Service Bulletin

Bulletin Number: SB09-001A *(Revised 9/01/09)*

Model / Serial Number(s): SWX630 / 8GD63001 - 9GD63050
SWX735 / 8GD73501 - 9GD73550
SWX525 / 8GD52501 - 9GD52550
SWX420 / 8GD42001 - 9GD42050
SWX315 / 8GD31501 - 9GD31550

Subject: Engine starter circuit breaker tripping. *(Note: This problem is applicable to CUMMINS QSC & QSB engines.)*

Figure 1 - battery box, viewed from above.

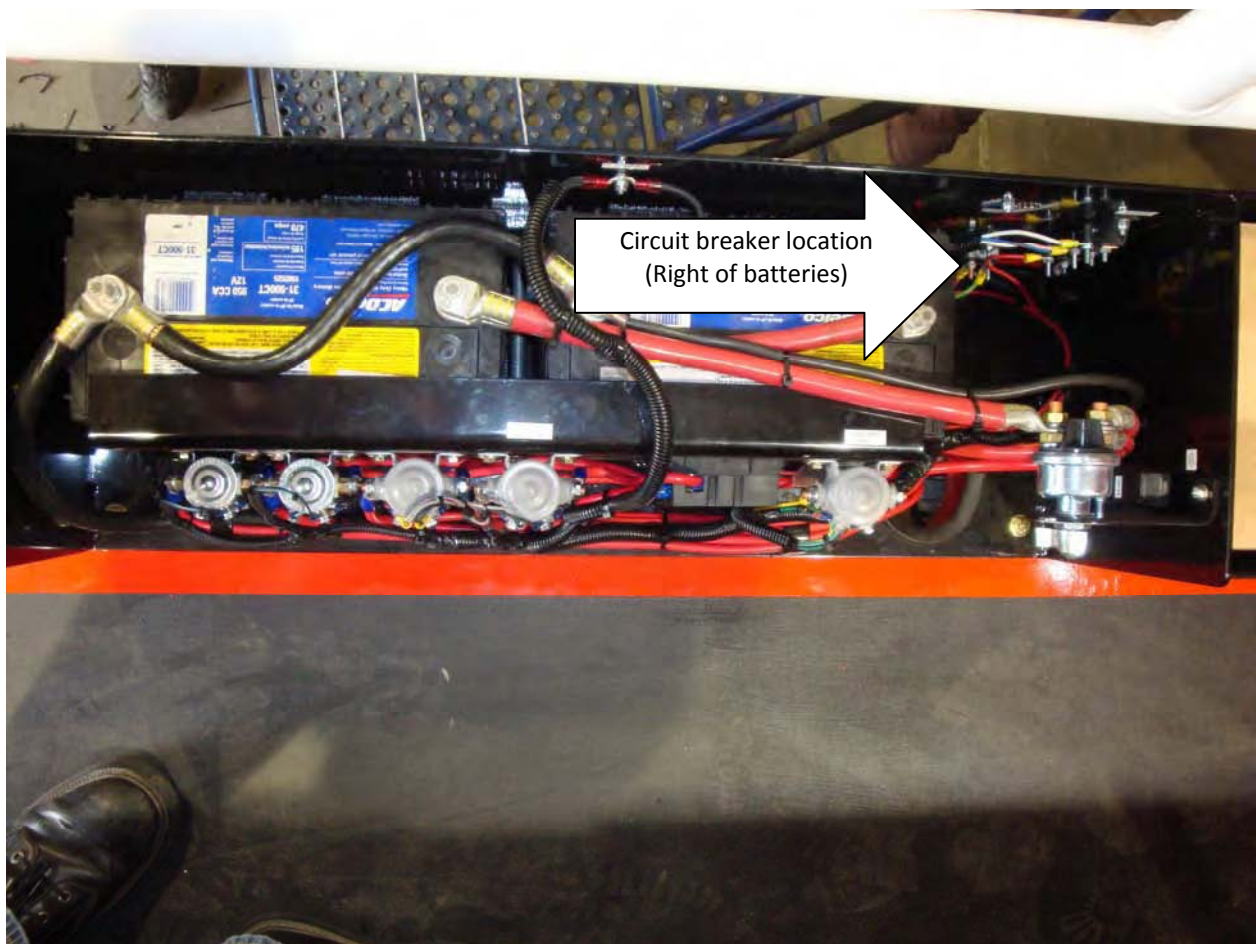
Cummins QSC engines equipped with “soft-start” type Delco-Remy starters may experience an elevated switching current which causes the provided 30A circuit breaker to trip, causing no-start condition. Per the manufacturer’s recommendation, this circuit may be retrofitted with a 50A, type I (automatic reset) breaker to prevent this from occurring.

The existing circuit breaker is located in the battery box, to the right of the batteries. The 50A auto reset breaker (Shuttlewagon P/N 179-082957) is a direct replacement and may be installed using existing hardware and wiring.
